RE: Job # 22-50073
2605 Clark Lane
Orange, Texas 77632

Subject: Structural Inspection

DT-68 FRAMING AND CONNECTIONS FOR OPENINGS

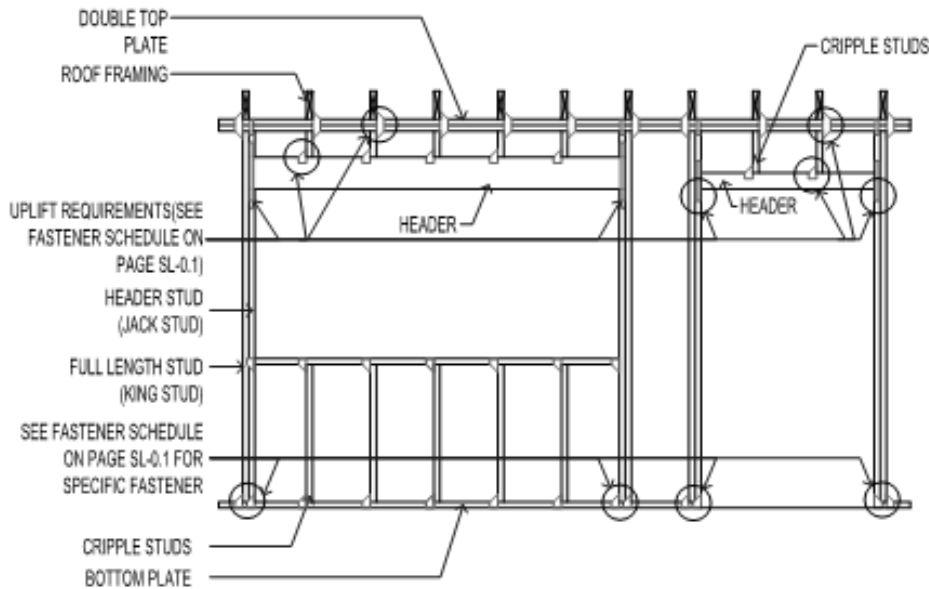
Stud wall/ header framing: The wall framing consisted of 2x6 syp for the sole plate, studs @ 16” o.c., and double top plate. The rafters are 2x6 syp @ 16” o.c. We found that the studs were missing clips and/or strapping, from the top plate to stud and stud to sole plate. We found that the header on the exterior load bearing walls were 2x6 syp boxed in. The 2x6 headers are undersized for supporting the loads from above. The headers are not strapped or clipped to the studs. The ceiling joists are 2x6 syp. The 2x6 rafters are resting on the top plate. The rafters are not strapped properly. Every other rafter had a H2.5A installed from rafter to top plate. This is not typical for a windstorm design. These straps are crucial for creating a continuous load path to the foundation.

Stud wall/ header framing: The wall framing consisted of 2x6 syp for the sole plate, studs @ 16" o.c., and double top plate. The rafters are 2x6 syp @ 16" o.c. We found that the studs were missing clips and/or strapping, from the top plate to stud and stud to sole plate. We found that the header on the exterior load bearing walls were 2x6 syp boxed in. The 2x6 headers are undersized for supporting the loads from above. The headers are not strapped or clipped to the studs. The ceiling joists are 2x6 syp. The 2x6 rafters are resting on the top plate. The rafters are not strapped properly. Every other rafter had a H2.5A installed from rafter to top plate. This is not typical for a windstorm design. These straps are crucial for creating a continuous load path to the foundation.

It is recommended to add Simpson H2.5A clips from top plate to stud and from stud to sole plate @ every stud location. Replace headers according to the span legend below. Add Simpson LSTA18 straps on each side of the headers. See DT-68 framing and connections for openings detail for guidance. Add Simpson H2.5A clips from every rafter to double top plate.

It is recommended to add Simpson H2.5A clips from top plate to stud and from stud to sole plate @ every stud location. Replace headers according to the span legend below. Add Simpson LSTA18 straps on each side of the headers. See DT-68 framing and connections for openings detail for guidance. Add Simpson H2.5A clips from every rafter to double top plate.
